Subject: FW: NEW (4-Series) Hoag Coffee Cart (McBride) DUE = Next Available QUICK HITTER
From: Jill Hundley <jhundley@vollrathco.com>
Date: 6/27/2022, 10:59 AM
To: David Bethel <ddb@davidbethel.com>

From: Sheila Oppeneer <sheila.oppeener@vollrathco.com>
Sent: Monday, July 11, 2022 4:26 PM
To: presaledesign <presaledesign@vollrathco.com>
Cc: James Edson <james.edson@vollrathco.com>; Anthony Bruni <anthony.bruni@vollrathco.com>; Jill Hundley <jhundley@vollrathco.com>; Michael Komendat <mkomendat@vollrathco.com>
Subject: Revision (4-Series) Hoag Coffee Cart (McBride) DUE = Next Available QUICK HITTER

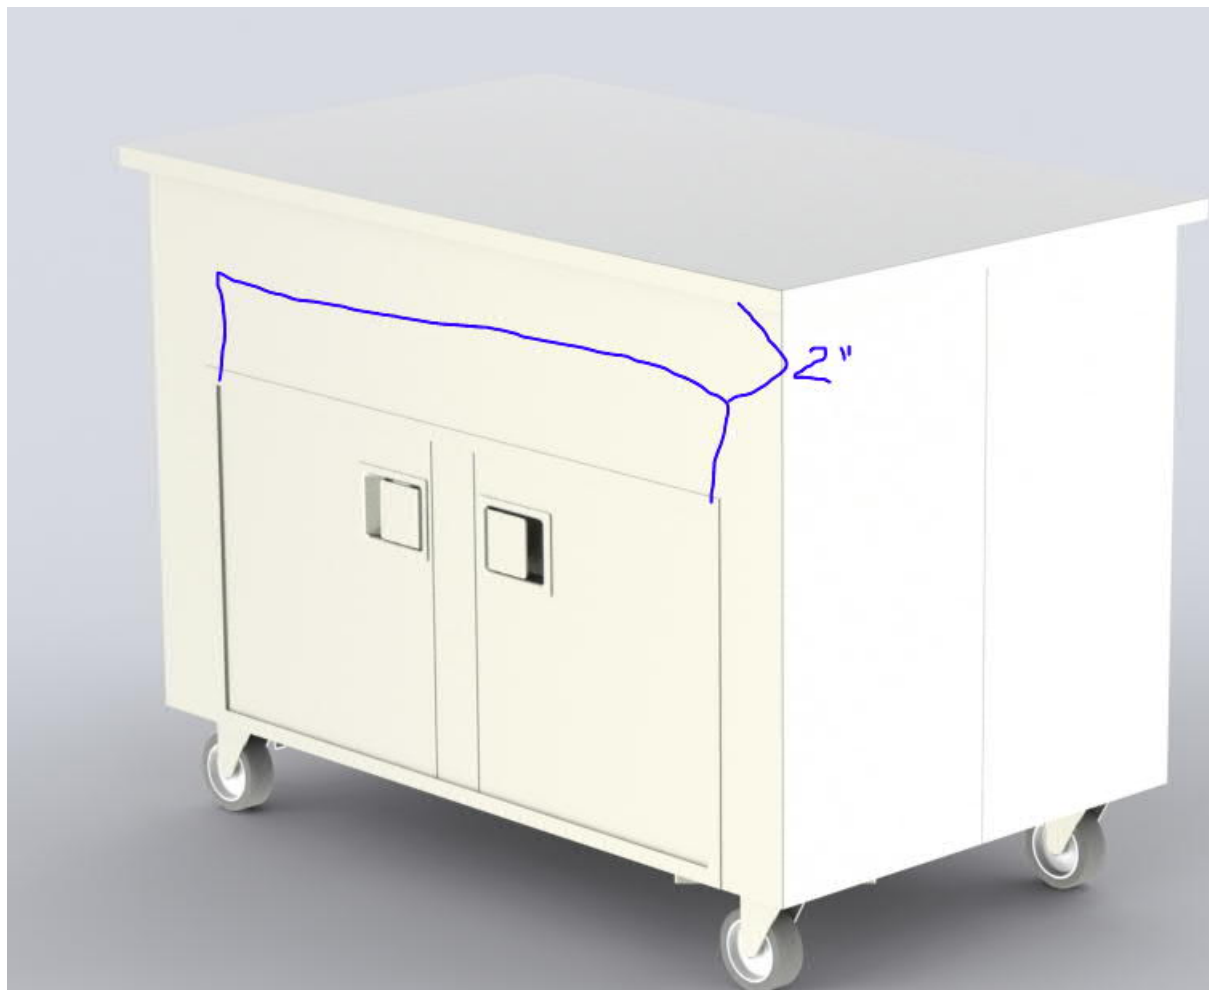
C-13386 is started.
ONLY MODIFICATION IS: top of doors to start 2" below countertop and go to the base of unit
as normal.

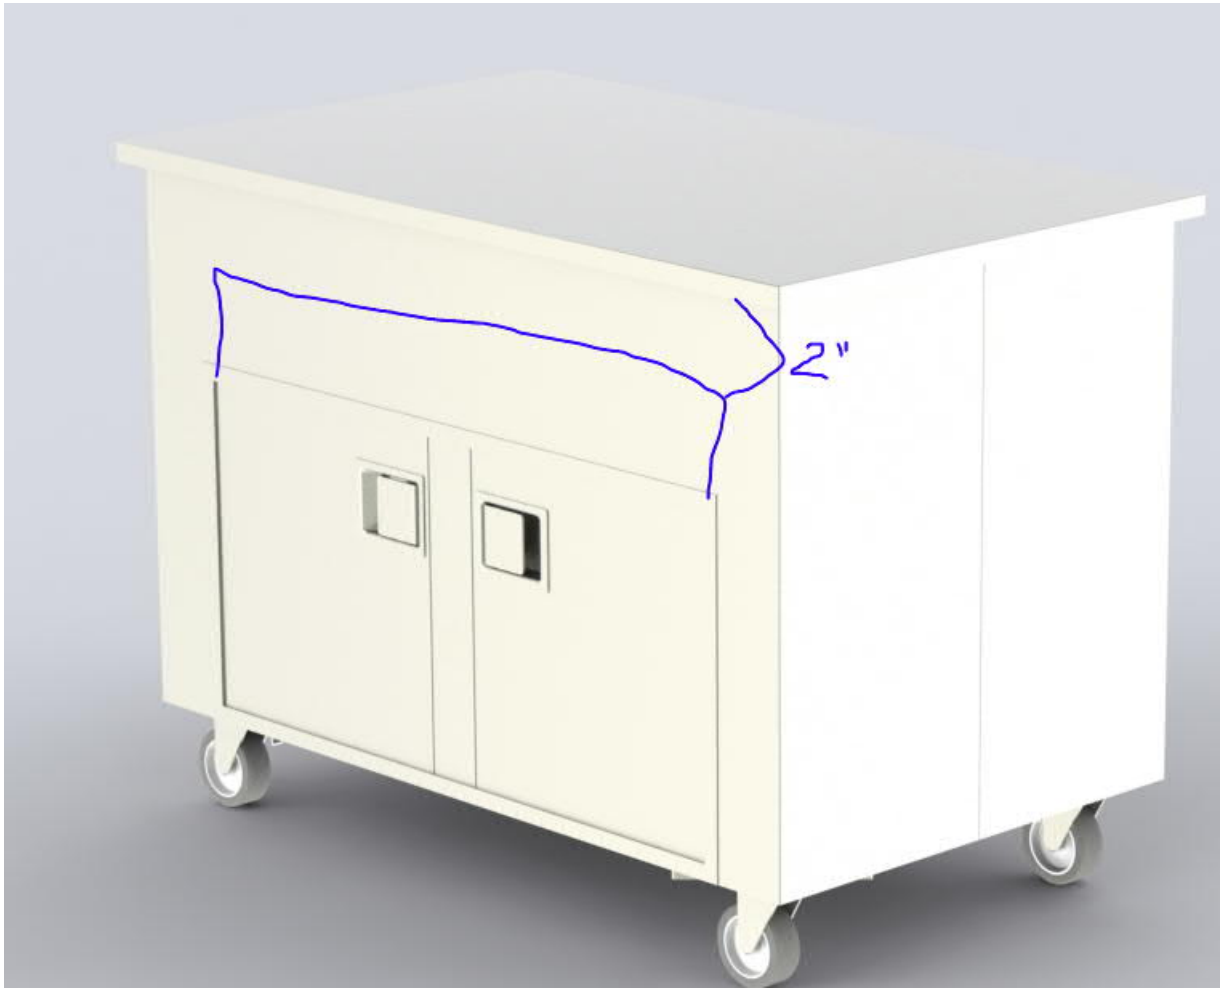
Customer has asked for 2 changes to the drawing:

1. Standard Black
2. Add tray slide to customer side
